**Final Drainage Report  
The Glen at Widefield Filing No. 10  
El Paso County, Colorado**

Kiowa Project No. 19016

May 27, 2020

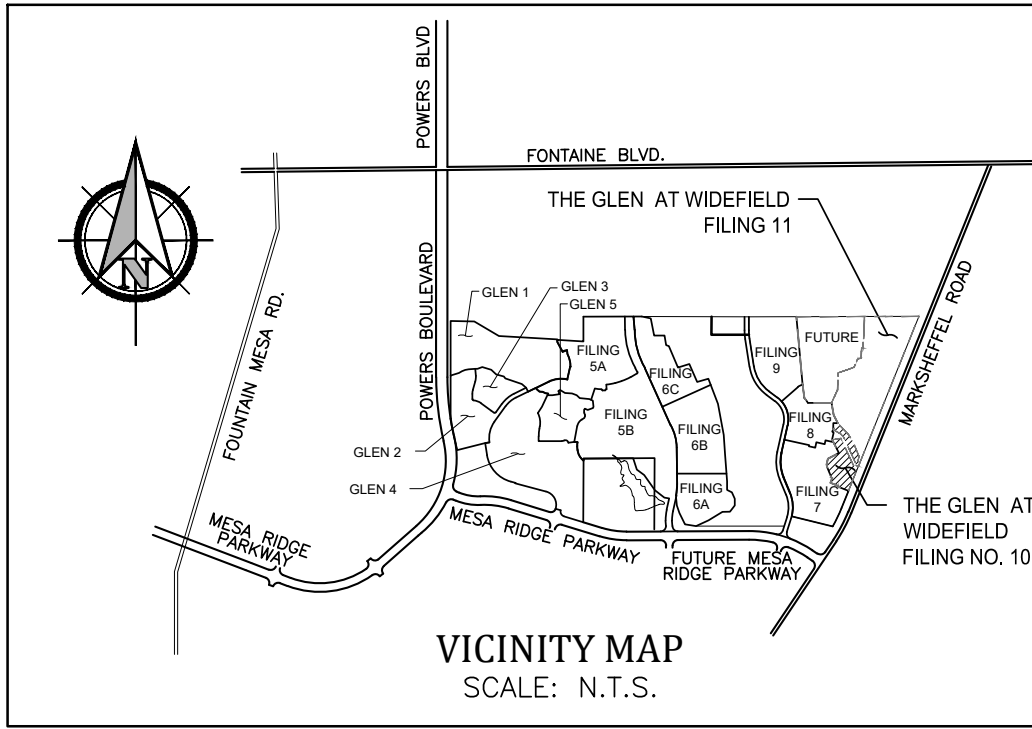
Please indicate that the CBC was also evaluated and as requested in the review #2 comment, please indicate size of this existing

Please indicate that the CBC was also evaluated and as requested in the review #2 comment, please indicate size of this existing culvert that is conveying the developed flow downstream of Peaceful Valley.

Review 2 comment: How is this culvert affected by the sites discharged flows? Please address in the narrative. Review 3: Unresolved

Review 2 comment: How is this culvert affected by the sites discharged flows? Please address in the narrative.  
Review 3: Unresolved. Please address in the narrative.
